RANGELINE BUSINESS PARK SUBDIVISION, UNIT TWO, RESUBDIVISION OF LOTS 14 & 15

APPLICATION NUMBER 3 DATE January 3, 2019
 APPLICANT Rangeline Business Park Subdivision, Unit Two, Resubdivision of Lots 14 & 15
 REQUEST Subdivision

DETAIL SITE PLAN

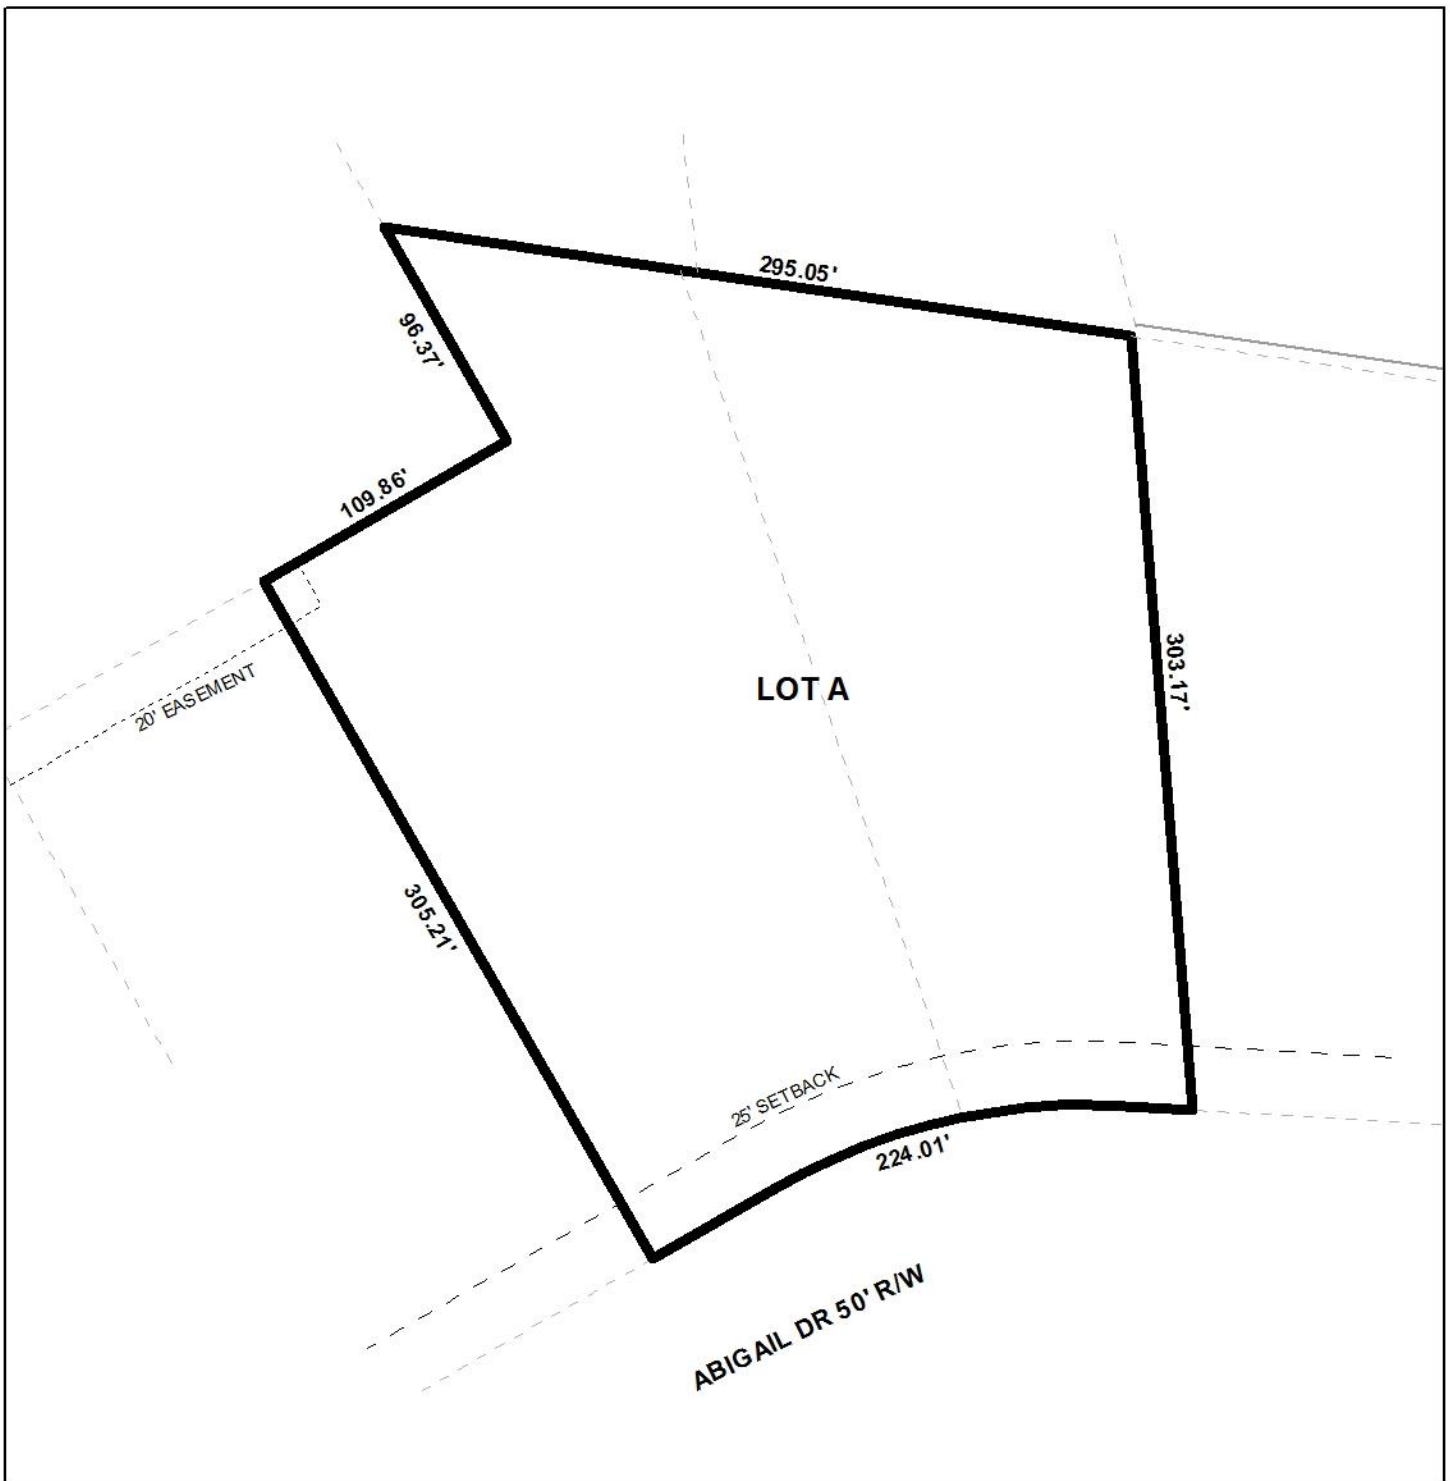
Engineering Comments: FINAL PLAT COMMENTS (should be addressed prior to submitting the FINAL PLAT for review and/or signature by the City Engineer):

- A. Provide all of the required information on the SUBDIVISION PLAT (i.e. signature blocks, signatures, certification statements, written legal description, required notes, legend, scale, bearings and distances) that is required by the current Alabama State Board of Licensure for Professional Engineers and Land Surveyors.

- B. Provide and label the monument set or found at each subdivision corner.
- C. Provide a legible vicinity map.
- D. Add a signature block for the Owner, Notary Public, Planning Commission, Traffic Engineer, and City Engineer.

- I. Add a note that sidewalk is required to be constructed, and/or repaired, along the frontage of each lot, or parcel, at time of new development or construction, unless a sidewalk waiver is approved.

- K. Add a note to the plat stating that all easements shall remain in effect until vacated through the proper Vacation process.
- L. Provide a copy of the FINAL SUBDIVISION PLAT to the Engineering Dept. for review. No signatures are required on this drawing.

The proposed lot has frontage along Abigail Drive, a minor street with curb and gutter, requiring a 50' right-of-way. Adequate right-of-way is illustrated, thus no additional dedications should be required.

The lot meets the minimum size requirements for lots served by public water and sanitary sewer systems, and is appropriately labeled in square feet and acres on the preliminary plat. This information should be retained on the Final Plat, if approved; or, provision of a table on the Final Plat providing the same information may suffice.

Regarding access management, the lot should comply with Traffic Engineering comments limiting the lot to one curb cut to Abigail Drive, with any changes in size, location and design to be approved by Traffic Engineering and conform to AASHTO standards.

Finally, the 25' minimum building setback line is illustrated along the street frontage, in compliance with Section V.D.9. of the Subdivision Regulations, and should be retained on the Final Plat, if approved.

- 1) retention of the lot sizes in square feet and acres on the Final Plat, or placement of a table on the Final Plat providing the same information;

- 2) retention of the 25' minimum building setback line;
- 3) compliance with Engineering comments: (FINAL PLAT COMMENTS (should be addressed prior to submitting the FINAL PLAT for review and/or signature by the City Engineer): A. Provide all of the required information on the SUBDIVISION PLAT (i.e. signature blocks, signatures, certification statements, written legal description, required notes, legend, scale, bearings and distances) that is required by the current Alabama State Board of Licensure for Professional Engineers and Land Surveyors. B. Provide and label the monument set or found at each subdivision corner. C. Provide a legible vicinity map. D. Add a signature block for the Owner, Notary Public, Planning Commission, Traffic Engineer, and City Engineer. E. Provide the Surveyor's Certificate and Signature. F. Provide the Owner's (notarized), Planning Commission, and Traffic Engineering signatures. G. Add a note to the SUBDIVISION PLAT stating that a Land Disturbance permit will be required for any land disturbing activity in accordance with Mobile City Code, Chapter 17, Storm Water Management and Flood Control; the City of Mobile, Alabama Flood Plain Management Plan (1984); and, the Rules For Erosion and Sedimentation Control and Storm Water Runoff Control. H. Add a note to the Plat stating that the approval of all applicable federal, state, and local agencies (including all storm water runoff, wetland and floodplain requirements) will be required prior to the issuance of a Land Disturbance permit. I. Add a note that sidewalk is required to be constructed, and/or repaired, along the frontage of each lot, or parcel, at time of new development or construction, unless a sidewalk waiver is approved. J. Add a note to the plat stating that all proposed detention facilities, common areas, and wetlands shall be the responsibility of the Property Owner(s), and not the responsibility of the City of Mobile. K. Add a note to the plat stating that all easements shall remain in effect until vacated through the proper Vacation process. L. Provide a copy of the FINAL SUBDIVISION PLAT to the Engineering Dept. for review. No signatures are required on this drawing. M. After addressing all of the FINAL SUBDIVISION PLAT review comments by the Engineering Dept. provide the red-line markup, the ORIGINAL (with all other signatures) and one (1) copy of the revised original (signatures not required) of the revised Final Plat to the Engineering Department.);

- 4) placement of a note on the Final Plat to comply with the following Traffic Engineering comments: (Lot is limited to one curb cut to Abigail Drive, with any changes in size, location and design to be approved by Traffic Engineering and conform to AASHTO standards. Any new on-site parking, including ADA handicap spaces, shall meet the minimum standards as defined in Section 64-6 of the City's Zoning Ordinance.);
